STAFF REPORT

Project Stylus Development LLC
Applicant: Stylus Development LLC; Agent: ORW Architecture

File no. AC-18-171

Consideration of a Major Modification consisting of the addition of four dwelling units to previously approved plans for an apartment building (AC-18-094) on approximately 1.1 acres located on the south side of East Barnett Road, approximately 600 feet east of Ellendale Drive within the MFR-30 (Multiple Family Residential – 20 to 30 dwelling units per gross acre) zoning district (371W32AB500).

Figure 1 - Blue line indicates approved footprint and location

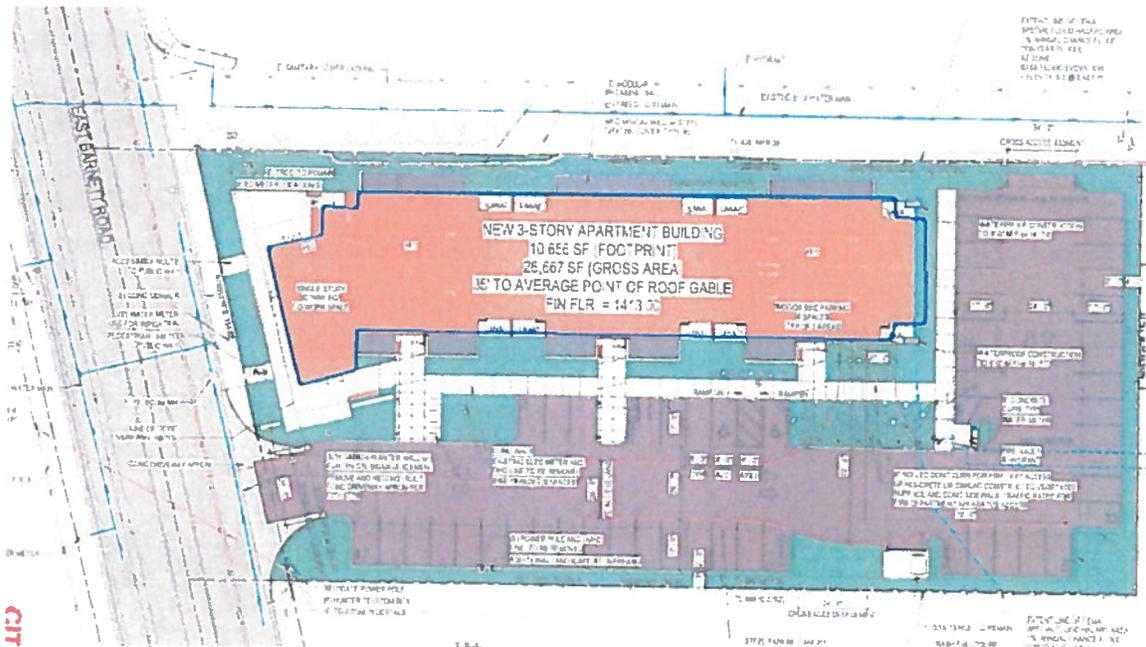
As this Major Modification request is focusing solely on the proposed changes to AC-18-094, MLDC 10.716A et seq. are only applicable to those areas.

Besides the addition of four dwelling units, these changes include a slight modification to the building footprint in order to move the building outside the floodzone, the addition of windows for the additional units, and vehicular parking spaces to accommodate the additional units.

CITY OF MEDFORD
EXHIBIT # 4
FILE # AC-18-171

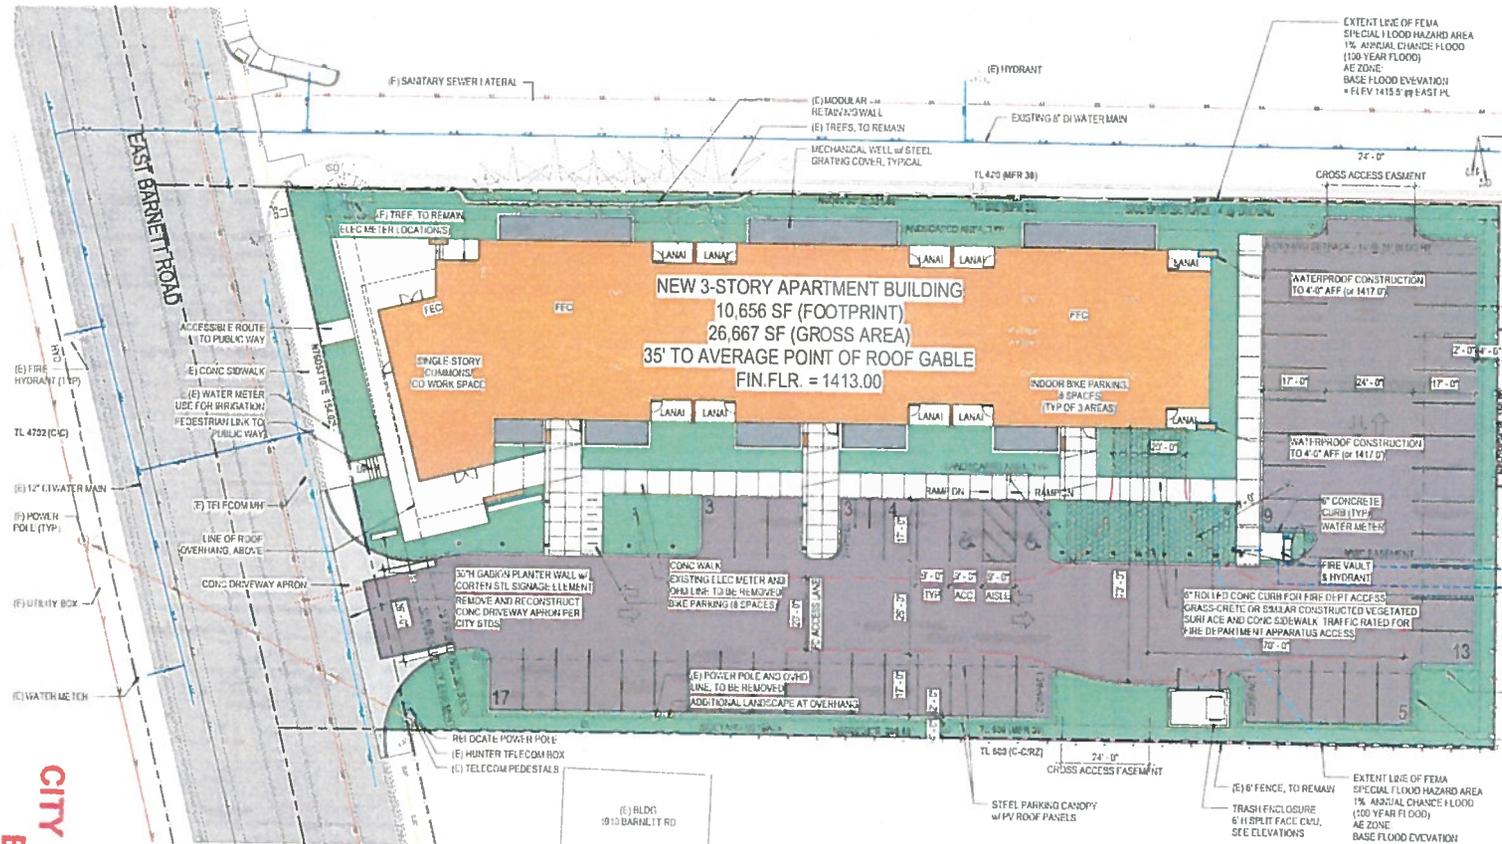
Parts of the property along the southerly property line are within a mapped AE zone with Base Flood Elevations and a designated floodway. The revised site plan shows the building footprint to be located entirely outside of the mapped floodzone.

Per the Memorandum (Exhibit M) received from the Floodplain Coordinator on December 11, 2018, a Floodplain Development Permit is required prior to development in the Special Flood Hazard Areas.
